Council Assessment Report

2015STH006 (MOD.2015.003 (DA.2014.035))

Sand Quarry Modifications to Conditions

Kings Highway, Bungendore

Figure 1

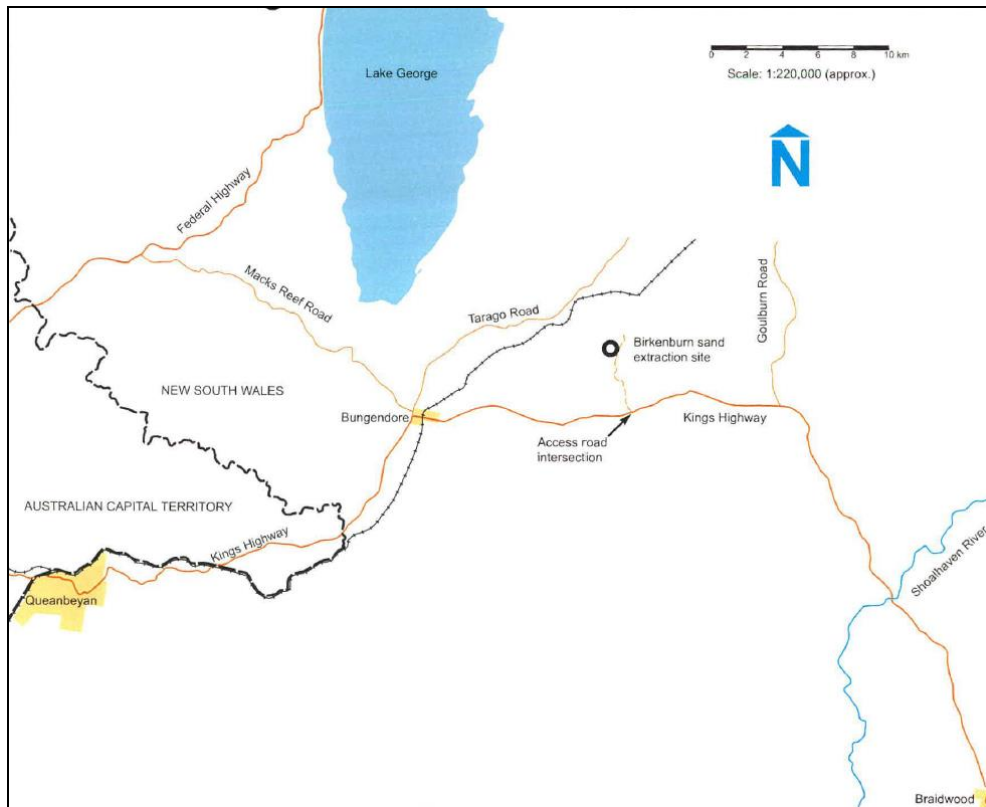
The modification application requests (with reference to figure 1):

- *New access road (right of carriageway) across Lot 50 DP 754878 (Section 1) to generally be Type 2 Road as specified in Table 2 of Yarrowlumla Development Control Plan Rural Zone and Palarang Council's Specification for Construction of Private Access Roads and Entrances. Roads are to have a central crown with cross falls of 3% for sealed and 5% for unsealed pavements.*
- *Internal Access road (Section 2) Review existing road alignment for provision passing bays Refer Item 33.*

The existing condition requires the entire access road to be constructed to Type 2 standard. The modification application has requested the following standard on the various sections of road:

The modification request is considered to be acceptable as the road standards proposed are likely to have less environmental impact but will still provide an appropriate standards of access. It is considered appropriate to reduce the road standard in Section 2 to a Type 1 road if passing bays are provided as required by Condition 33. Condition 33 is also required to be modified to ensure Section 3 in MOD.2015.003 is identified and reference is made to ARRB Unsealed Roads Manual 2009.

- Design the access road, identified as Section 2 on the approved plan identified as Figure 1: Sand extraction site Road Sections – for reference to proposed design standards modifications, in MOD.2015.003, generally as a Type 2 Road as specified in Table 2 of Yarrowlumla Development Control Plan Rural Zone and Palerang Council's Specification for Construction of Private Access Roads and Entrances. To minimise clearing and earthworks extents, the road width may be reduced to a Type 1 Road, subject to provision of passing bays, as required in Condition 33.

- Design the access road, identified as Section 3 in MOD.2015.003, generally as a Type 4C, as per standards specified in Condition 33.
33. When designing the access road, identified as Section 3 in MOD.2015.003, refer to ARRB Unsealed Roads Manual 2009, to provide guidance to design requirements for this class of road (ARRB Class 4C).
Intermediate sight distance ($ISD = 2 \times SSD$), measured from 1.1 m to 1.25 m for a design speed of up to 40km/h must be provided in the design. Restricted visibility widening to 2 lanes must be designed for locations where ISD is not economically achievable.
Base course gravel where unsealed is to be erosion-resistant and conform to the specification for unsealed road pavements. Detailed construction drawings are not required for this class of road, however road location(s), longitudinal grades and stream

Gravel Road (W5-19) signage

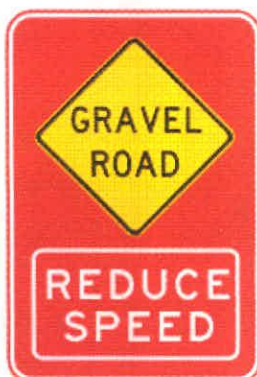
For the intersection with the Kings Highway and sealed section of access road provide road signage to and traffic control devices to Austroads (and RMS supplements) standards.

For the unsealed internal road, provide warning signage suitable to gravel roads and traffic control devices to Australian standards, including RMS supplements.

Suggested standard warning signage for the gravel section of the access road in accordance with Australian Standard AS 1742 and RMS Supplements may include the following signs;

37. For the intersection with Kings Highway and the sealed section of road, provide signage and traffic control devices to Austroads (and RMS supplements) standards.

For the unsealed internal road, provide warning signage suitable for unsealed roads to Australian standard AS 1742, including RMS supplements.
